UNITED STATES PATENT AND TRADEMARK OFFICE

Office Action Summary

10/581,970

DETAILED ACTION

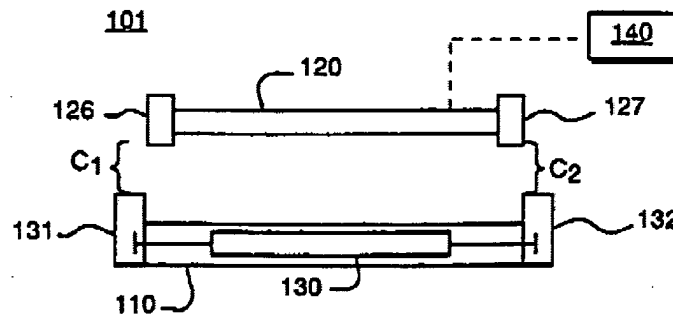
Reed teaches a device (Fig. 4B above imported from Reed) for measuring radiant energy comprising:

a carrier (120 in Fig. 4B; in paragraph [0054]) including first means allowing absorption of radiant energy, and second means enabling provision of one or more electric signals in relation to the absorbed radiant energy (IR energy sensor membrane 120 in Fig. 4B; on line 9 in paragraph [0054]); and

a substrate (110 in Fig. 4B; on line 3 in paragraph [0054]) including reading means (130) for reading the electric signals, the carrier being mobile (by levitation mechanism 140 in Fig. 4B; on line 10 in paragraph [0054]) relative to the substrate.

Regarding dependent claim 44, as illustrated in Fig. 4B Reed teaches a device for measuring radiant energy according to claim 38, configured to take up a position in which the carrier is neither attached to nor in contact with the substrate.

Regarding dependent claim 45, as illustrated in Fig. 4B by using a levitating mechanism 140 as discussed above Reed teaches a device for measuring radiant energy, configured to take up a position in which the carrier is in levitation with respect to the substrate.

Regarding dependent claim 46, as illustrated in Fig. 4A and as described in paragraph [0057] for post-absorption readouts Reed teaches a device for measuring radiant energy according to claim 42, the position being a position in which the device is configured to take a measurement.
